January 20, 2016  
Project No. 9101110001

**Subject: Response to U.S. Environmental Protection Agency (EPA) email on  
Transition Criteria, dated 10 November 2015  
Former Fuel Storage Area (ST012)  
Former Williams Air Force Base  
Mesa, Arizona**

Responses to EPA email dated 10 November 2015  
Transition Criteria

### Weekly progress report 11/6/15: LSZ

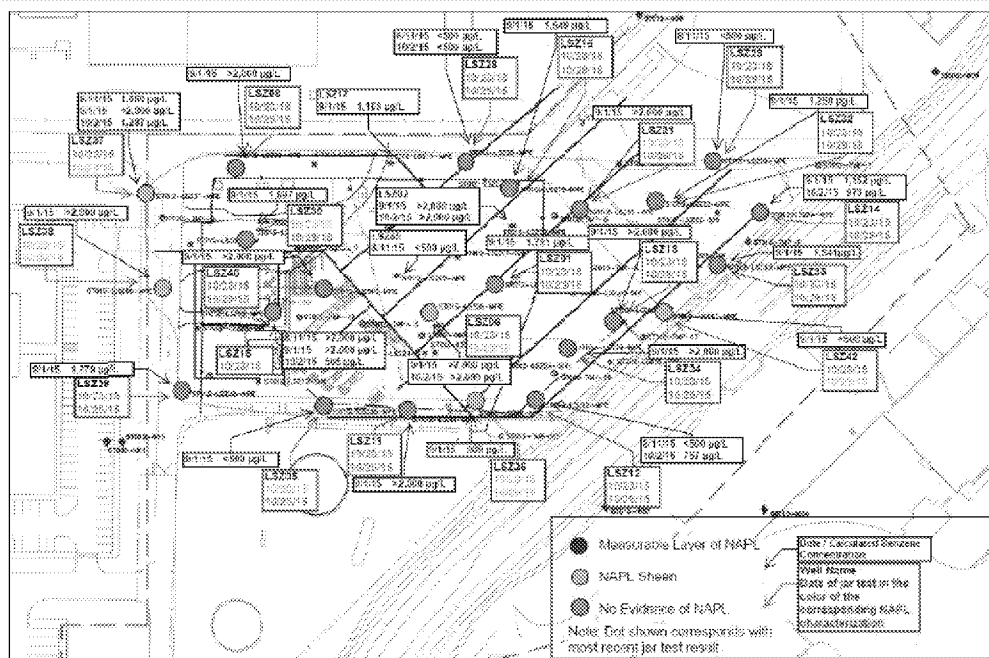
**Analysis:** EPA considers 100 µg/l of benzene in groundwater an appropriate target for a successful remediation, and would not support terminating steam treatment before the stated target (100 – 500 µg/l) is reached.

**Benzene Concentrations in LSZ Exceed 500 µg/L; Criteria has not been met for LSZ**

### Weekly progress report 11/6/15: UWBZ

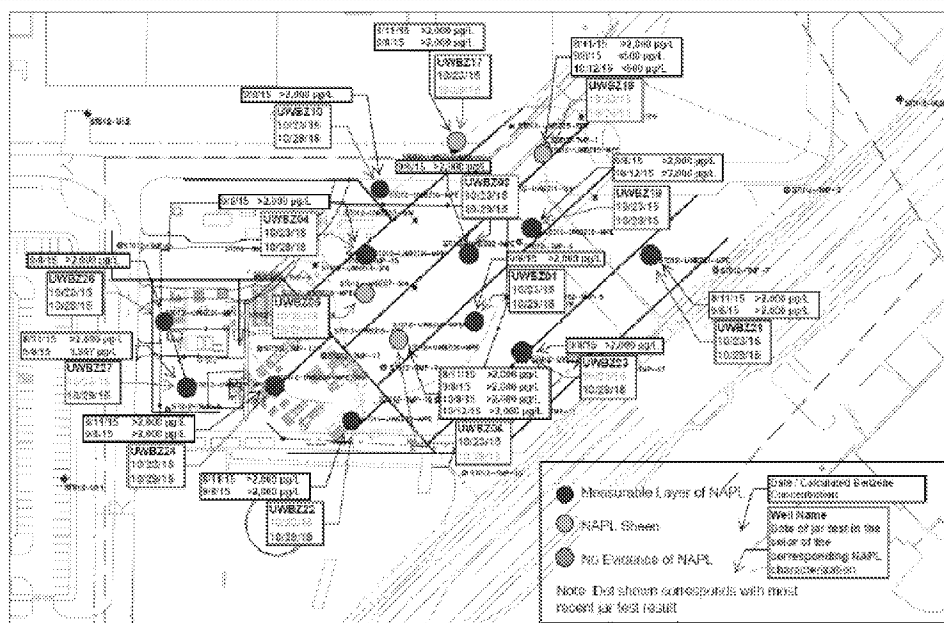
**Benzene Concentrations in UWBZ exceed 500 µg/L; significant NAPL present, Criteria has not been met for UWBZ**

Figure 4. Daily Mass Removed

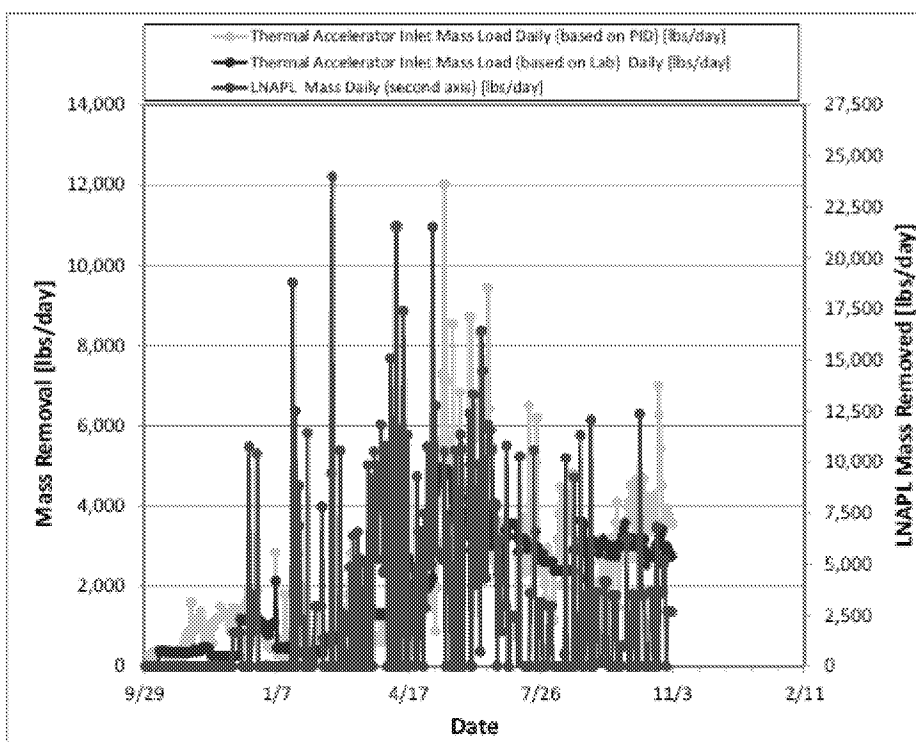
**Analysis:** Current LNAPL recovery is at 30% of peak removal rate; vapor recovery is 50% of peak removal rate; Criteria for termination of steam injection has not been met. EPA considers the criteria of 10% of the peak mass recovery to be high compared to the mass recovery rates that have been used to support thermal treatment termination at other sites. We cannot support termination of treatment when thousands of pounds of contaminant mass are being extracted daily.

**Response:** Mass recovery rates used to support thermal treatment termination at other sites may not be directly comparable depending on the circumstances of those sites. Specifically, this site includes known NAPL mass outside of the TTZ and an active EBR phase planned for post-SEE. This additional remedial step may not be consistent with designs at other sites. A target of 10% of peak mass removal is appropriate for ST012 because of the follow-on EBR planned.

As presented in the 23 November and 17 December BCT calls, peak mass removal occurred on 14 May at 22,506 pounds per day. Total mass removal (the RD/RAWP criterion) has dropped significantly since the peak. Currently the total mass removal rate is ~20 to 40% of the peak with an LNAPL removal increase following the recent coordinated depressurization in all three zones. Mass recovery rates have fluctuated and were as low as about 12% in mid December (updated graphs below):

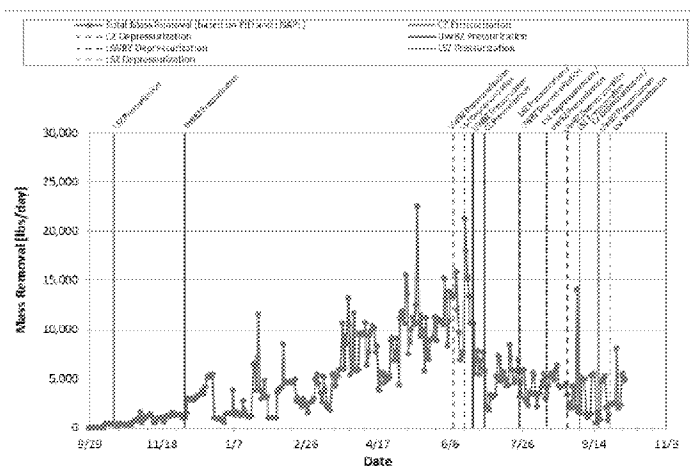
**Analysis:** This criterion is nonspecific. The purpose of pressure cycling, and indicated in the statements above is to enhance volatilization of contaminants. It is not intended to improve mobilization and recovery of NAPL which may have been retarded by premature initiation of pressure cycling. Ideally, the bulk of NAPL should be removed first before initiation of pressure cycling as the finishing step. As long as NAPL is being recovered, steam injection should continue, then institute pressure cycling to remove the last of the volatiles. It is unfortunate that we did not discuss criteria for initiation of pressure cycling in the work plan.

**Response:** As indicated in the criteria description, the pressure cycling can be initiated once TTZ temperatures have stabilized to enhance removal of volatile LNAPL constituents (i.e., benzene). This was the basis for the decision to initiate pressure cycling with less focus on maximizing LNAPL removal. In addition, the expected perimeter contribution of LNAPL limits the validity of elimination of LNAPL removal as a criterion for initiating pressure cycling. The design of SEE and the decision to initiate pressure cycling was based on the achievement of temperatures and breakthrough of steam to extraction wells. MPE well vapor monitoring temperatures, TMP data, estimated formation water temperatures were all considered. Initiation of pressure cycling was reviewed on a BCT call on 27 May 2015 prior to initiation and again at the 24 June 2015 BCT meeting prior to expansion beyond the northern portion of the UWBZ. It has been discussed at each BCT call/meeting since.

October BCT Presentation Slide 30

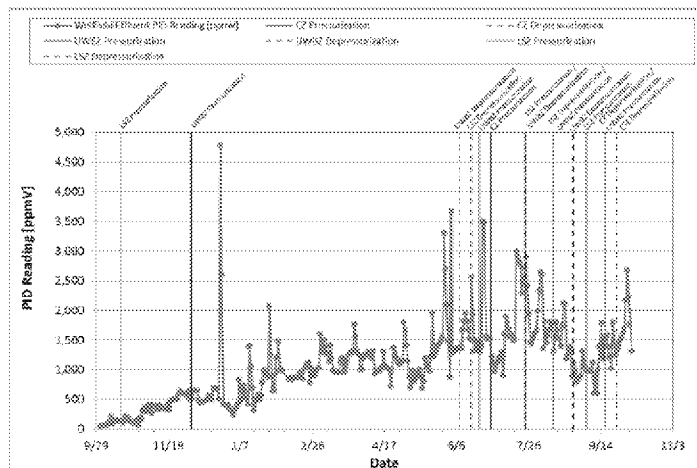
**NAPL Recovery was increasing up until the time pressure cycling was initiated. Did decline in recovery rate occur because pressure cycling was initiated early? Consider the analogy of liquid recovery with pressure cycling similar to turning spigot of garden hose on and off....**

**Response:** The peak NAPL removal occurred in early to mid-May. This coincided with the establishment of steam breakthrough at several wells. In the last two weeks of May and first week of June, NAPL removal was reduced from the peak. Depressurization cycles were initiated in the UWBZ and LSZ in early- and mid-June and the NAPL removal increased again immediately following the LSZ depressurization. These data would indicate the NAPL removal had started to decrease from peak and that the initiation of the pressure cycling increased NAPL recovery. Please note that the pressure cycling did include continued steam injection and flushing between injection and extraction wells, just at a lower rate than before. Initiating depressurization was also done to minimize the migration of steam outside of the TTZ. Complete pressure cycling by shutting off the steam injection fully was not initiated in the CZ, UWBZ and LSZ until 11 November 2015, 14 October 2015, and 25 September 2015 respectively.

## Site ST012 SEE Average Temperatures by Zone

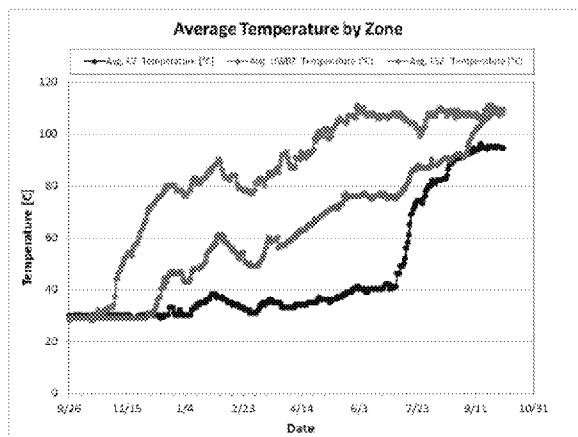
**Analysis:** According to slide 20 from Oct 15, the target temperature for the CZ is ~ 100C, which has almost been met. The target for the UWBZ is ~114C, which has almost been met. The target for the LSZ is ~134C, which has not been met.

**Response:** The slide from the October 2015 BCT call includes averages of all operating and reliable thermocouples within each TTZ at that time. As noted previously in the September BCT call, the average in the LSZ includes thermocouples to a depth of approximately 245 ft bgs (approximately the same depth as the bottom of the steam injection screens). Due to buoyancy effects, injected steam is not able to heat the lower portions of the injection interval and steam temperatures have not been observed at 240 ft bgs and below in the TTZ, except at a few monitoring locations. Limited heating of the bottom of the TTZ was anticipated during the design and is acceptable because the historical low groundwater table at the site of approximately 232 ft bgs limited the NAPL contamination to be primarily above 235 ft bgs. When only the thermocouples in the LSZ above 235 ft bgs are considered, the average LSZ temperature is approximately 10°C higher and as of the end of December just prior to the latest depressurization was approximately 122°C.

In addition to the effects of the lower thermocouples on the average TTZ temperatures, the failure of several Temperature Monitoring Points (TMPs) plays a role in lowering the average calculated temperature in each zone. TMPs have failed when liquids (groundwater, NAPL, and condensed steam) have penetrated both the grout seal around the TMP casing and the threaded joints of the TMP casing. Once a TMP has failed, it is removed from the average temperature calculations and is only included again if successful repairs are implemented. In general, there is a correlation between the progression of heating and timing of the TMP failures, indicating that the arrival of the steam front at the TMP usually coincides with the failure of the TMP. As such, failed TMPs were typically at steam temperatures at the time of failure and their removal from the average temperature calculations tends to lower the overall calculated average. As a result, calculated average temperatures are biased low. To evaluate the average temperature including the failed TMPs, average temperatures by zone using the maximum temperature achieved at each temperature sensor location throughout the project were calculated. This average includes maximum temperatures recorded at the failed TMPs before their failure. These averages are shown in the table below and demonstrate that target treatment temperatures have been achieved in all zones. In addition, steam breakthrough has been achieved at all interior MPE wells where it was expected (see summary table).
